# STAFF RECOMMENDATION

NCPC File No. 5164

**JOHN F. KENNEDY CENTER FOR THE PERFORMING ARTS  
RIVER TERRACE STAIRS TO THE ROCK CREEK AND POTOMAC PARKWAY TRAIL  
2700 F Street, NW  
Washington, D.C.**

October 25, 2007

5.0 Central Pair of Stairs

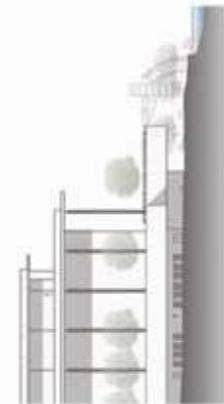
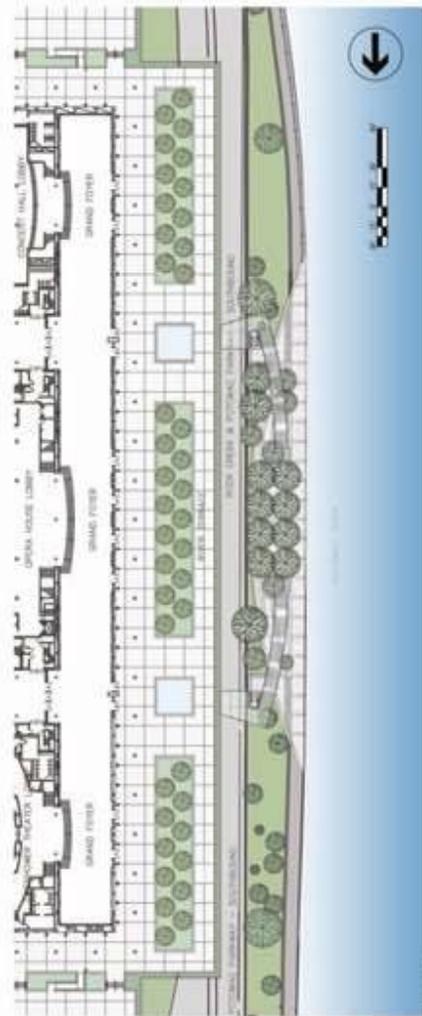
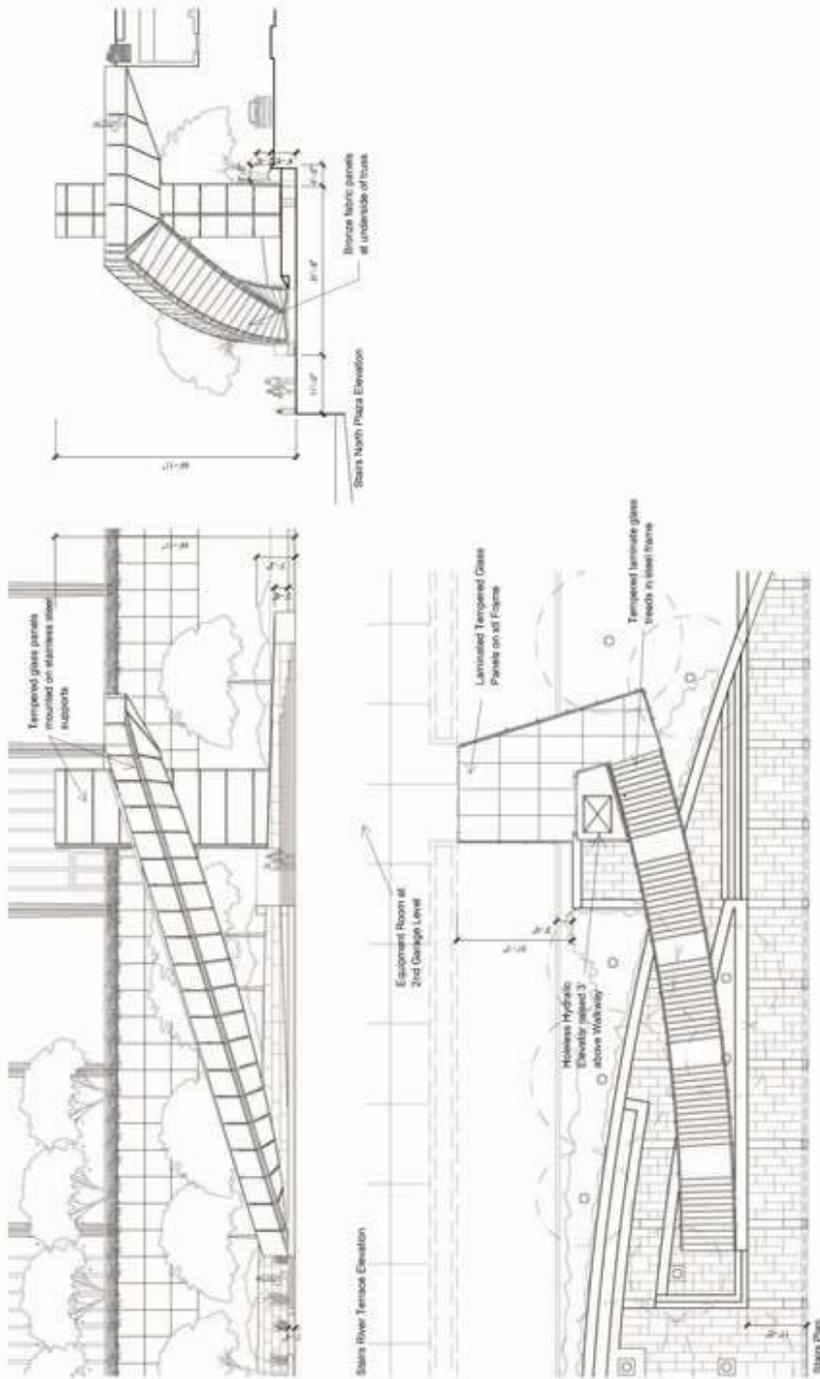
DDOT should continue to consult with the Kennedy Center, the National Park Service, the Commission staff and others about the stair and plaza materials as the design is developed further.

The effect that any of the plaza elements will have on views from the parkway should be carefully studied and the concern stated in the National Park Service's October 10, 2007 letter about the height of the retaining wall addressed. (The letter is attached to this report.)

DDOT should ensure that the stair design is welcoming, and that the platforms at the terrace level and the landings are inviting to patrons, as recommended in the Kennedy Center's September 28, 2007 letter. (The letter will be attached to this report.)
